Our Case Number: ABP-313892-22

Re: Bus Connects Blanchardstown to City Centre Core Bus Corridor Scheme
Blanchardstown to Dublin City Centre

Ref No ABP 313892

Blanchardstown to City Centre Bus Connects

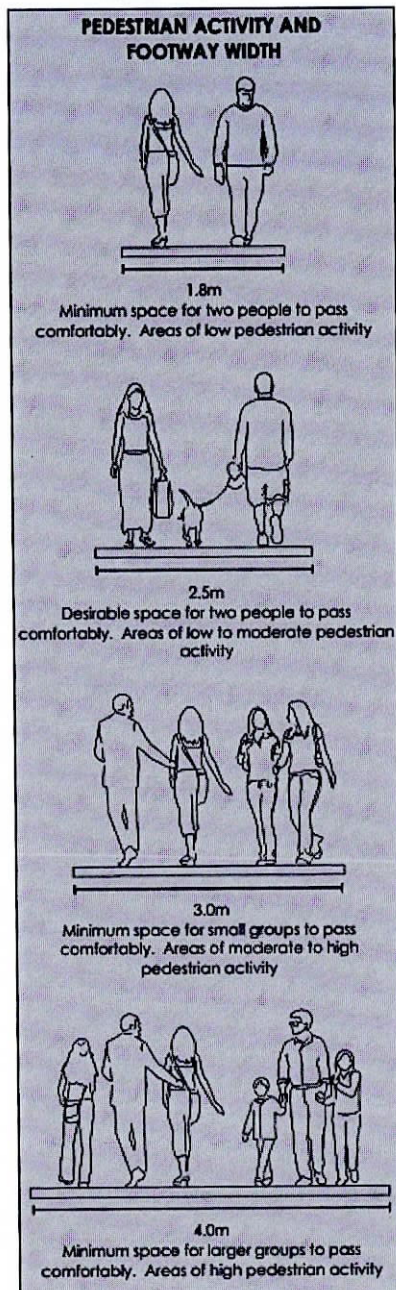
The manual references the UK *Pedestrian Comfort Guidance for London* and the associated figure below.

Accordingly, this figure clearly shows that the footpath environment at 136-142 Navan is not purely residential and is currently aligned with the third scenario for 3.0m width due the presence of the bus stop, schools and care homes. I also note the manual states:
